ADDENDUM NUMBER TWO

Date: March 22, 2016

Re: UNC Charlotte – Residence Dining Hall Renovation
SCO ID: 14-11273-02A
JPA Project #: 15NCC491

WALL & PARTITION TYPE SCHEDULE

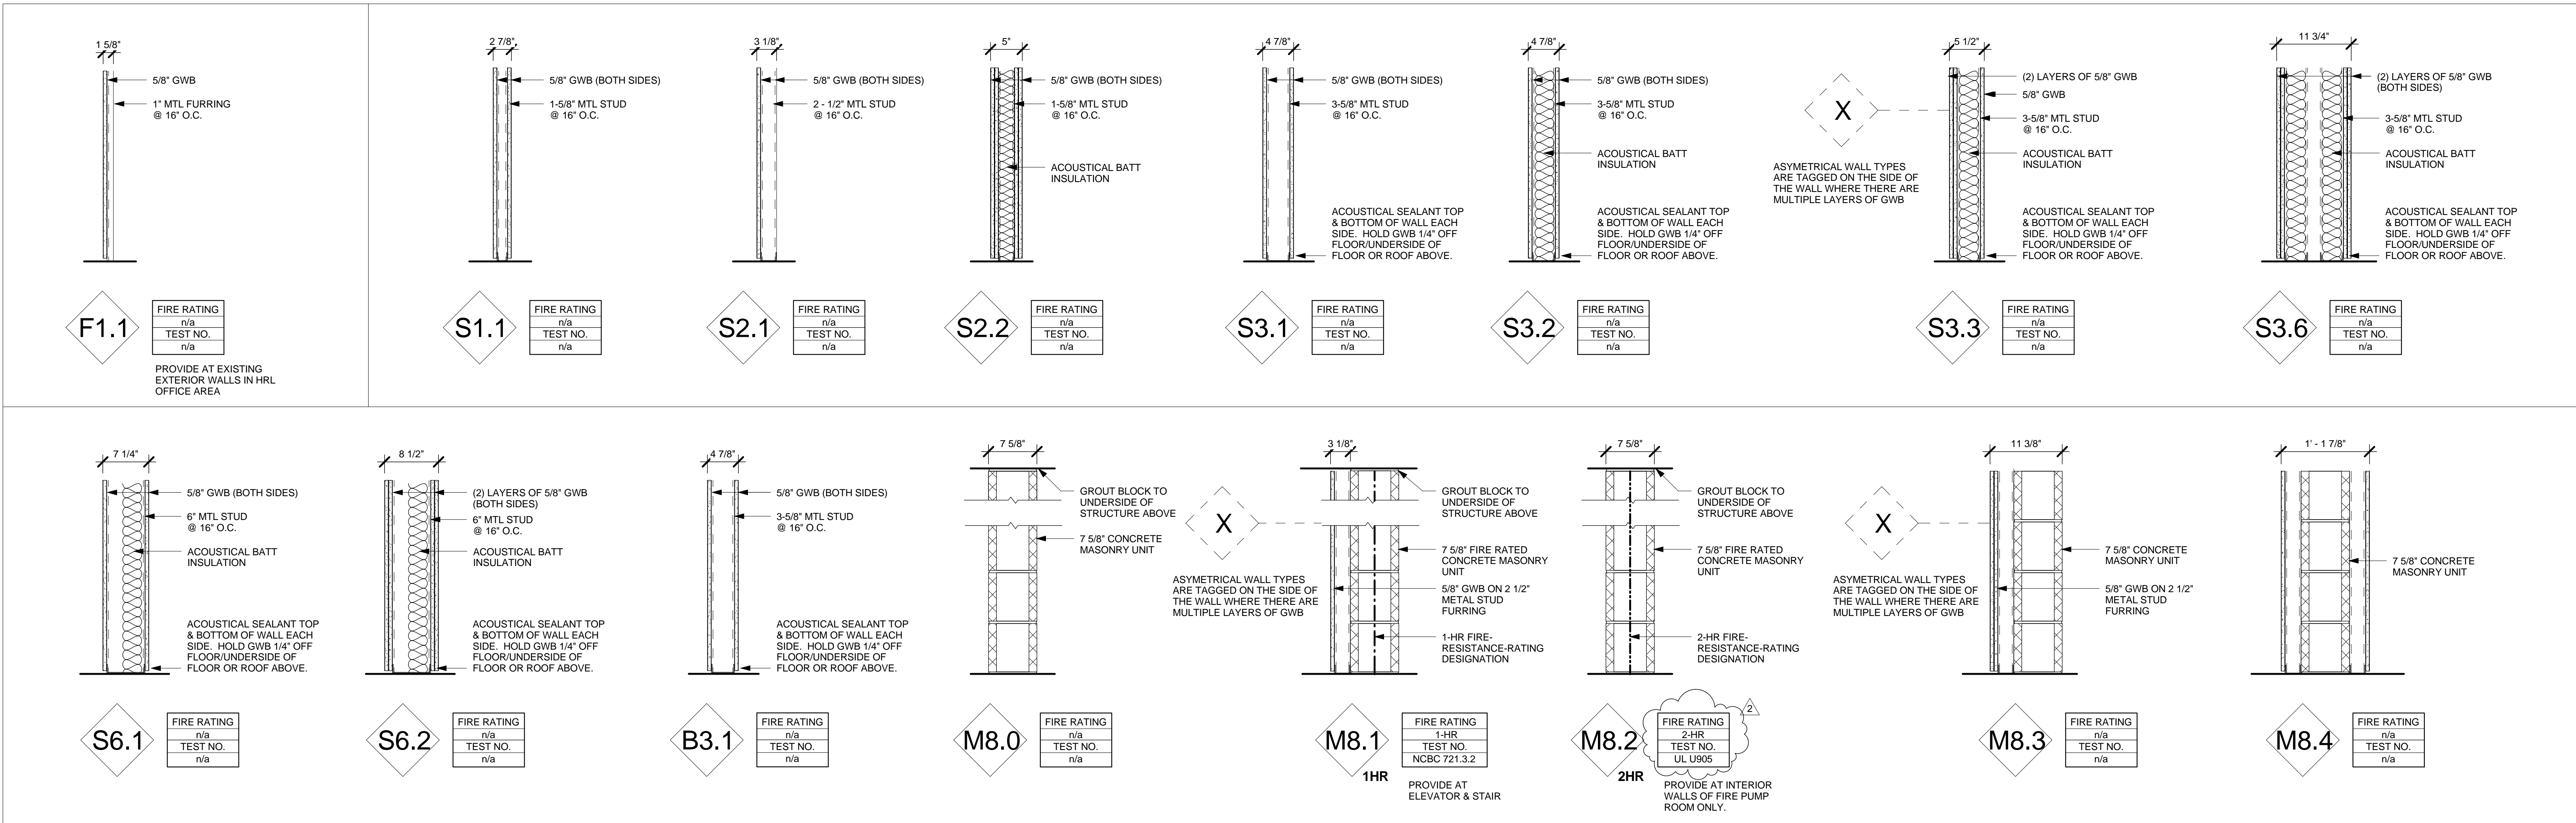
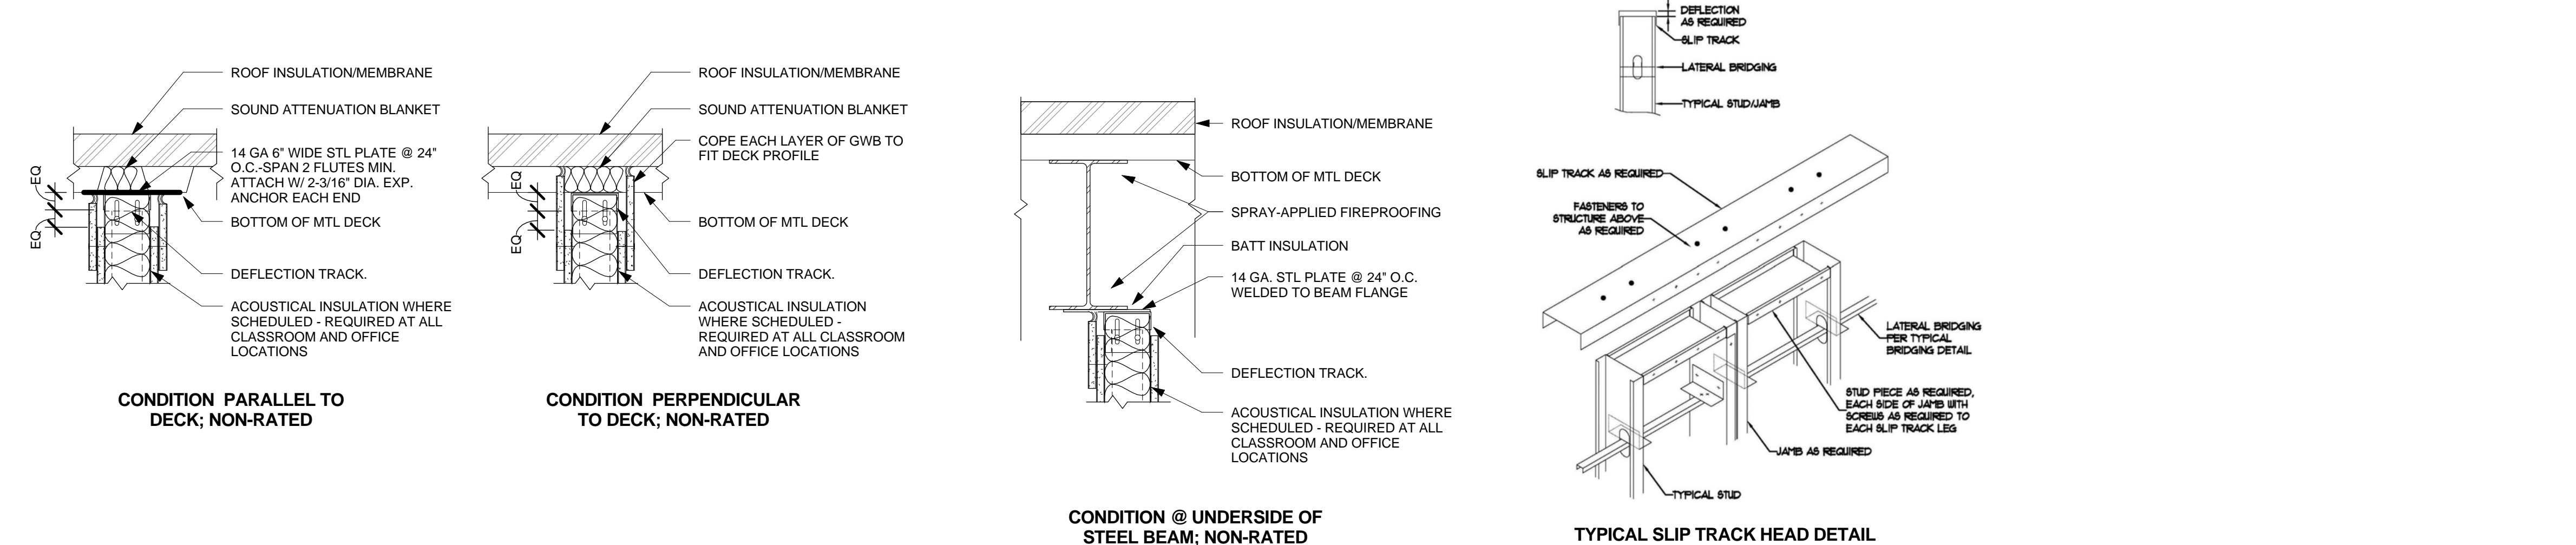
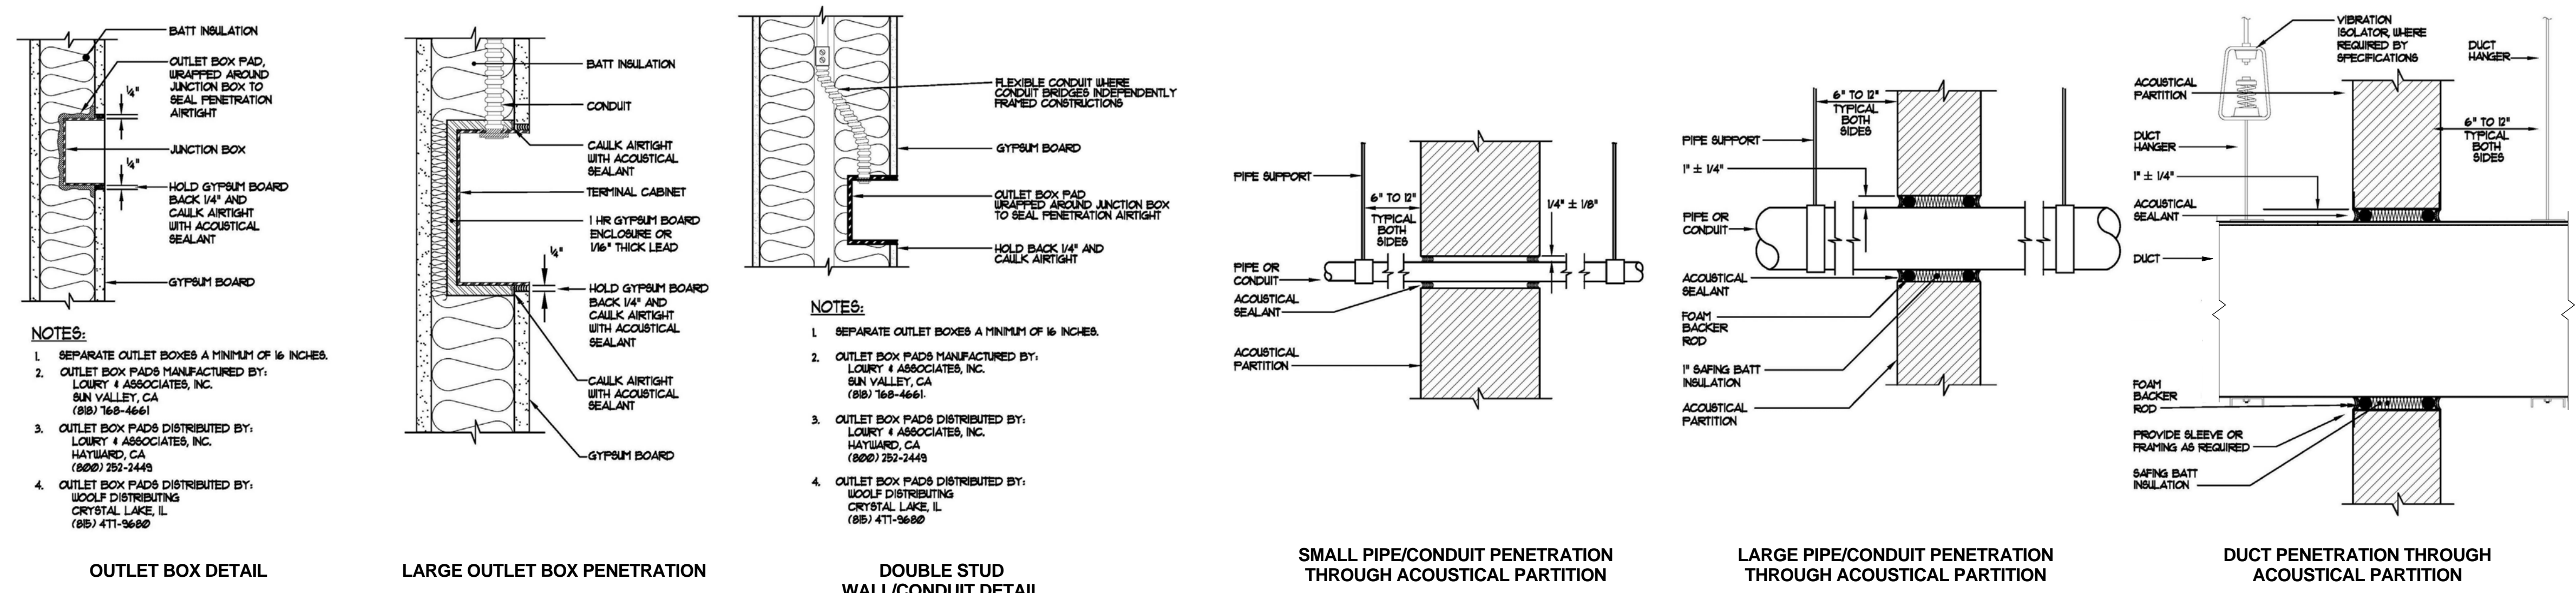
Item 17. General Drawing Sheet G-301: Replace drawing sheet in its entirety with included new G-301. Wall & Partition Type Schedule: Change Test No. reference for the M8.2 rated wall type from “UL U906” to “UL U905” so it correlates to the Code Summary Sheet on G-101 and the UL design shown on G-302.

B5 DEMOLITION BUILDING ELEVATION - NORTH
1/8" = 1'-0"

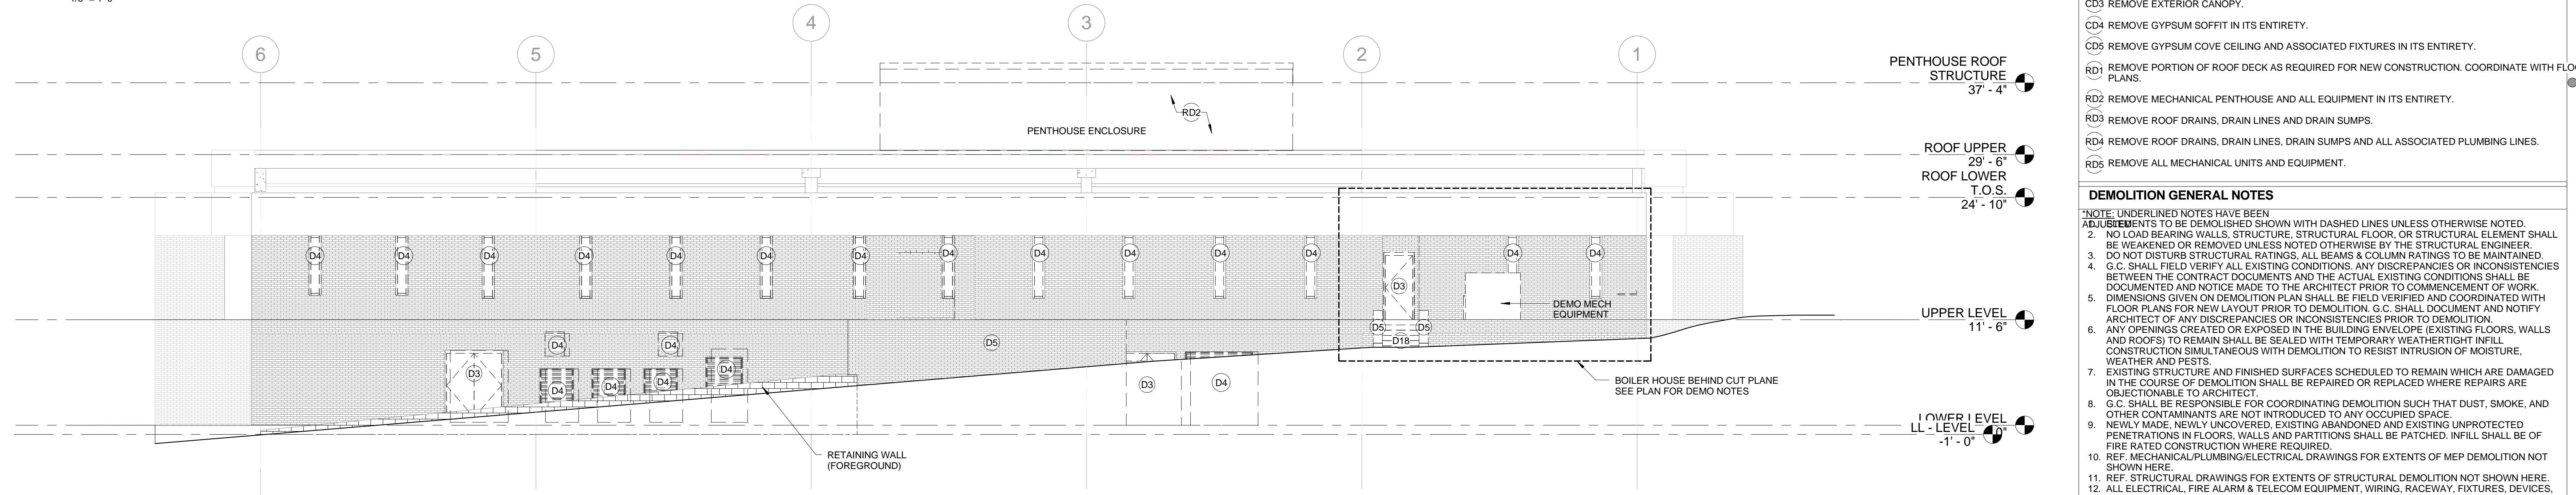
Item 23. Architectural Demolition sheet AD-201: Replace drawing sheet in its entirety with included new AD-201. Detail B5 – Change keynote D2 on the lower level near gridline 6 to be D2, as the panel to the left of the door is an existing louver on the exterior and gypsum panel on the interior.
